BIOGAS TO ELECTRICITY GENERATION GROUP PROJECT IN INDIA

Project Title	Biogas to electricity generation group project in India
Version	03
Report ID	ET-006414

Report Title	Validation report of “Biogas to electricity generation group project in India”
Client	EKI Energy Services Limited
Date of Issue	09/05/2024

Figure No. 4: Project Boundary

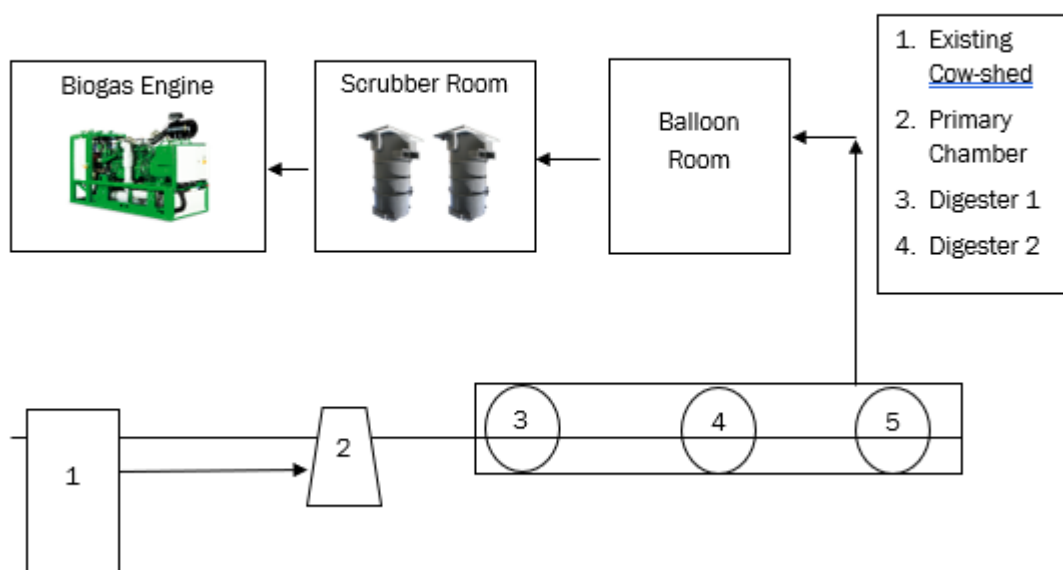
CAR ID	06	Section no.	3.3.3	Date: 27/03/2023
Description of CAR				
1. PP need to mention the whether the N₂O gas is included or not in section 3.3 Project Boundary of PD version 1 dated 13/3/2023. 2. In section 3.3 of PD version 1 dated 13/3/2023, PP need to give the appropriate name for the second block in figure named Project Boundary. ‘Primary’ word does not explain the nature and type of procedure/ function of that apparatus.				
Project participant response				Date: 29/05/2023

1. Section 3.3 has now been updated of the revised VCS PD. 2. Appropriate name for second block has now been mentioned in section 3.3 of the revised VCS PD.				
Documentation provided by project participant				
Change in the PD	Section (s): 3.3		New Version No: 02	
Change in the ER xls	Worksheet (s):		New Version No:	
Other:	NA			
VVB assessment				Date: 2/6/2023
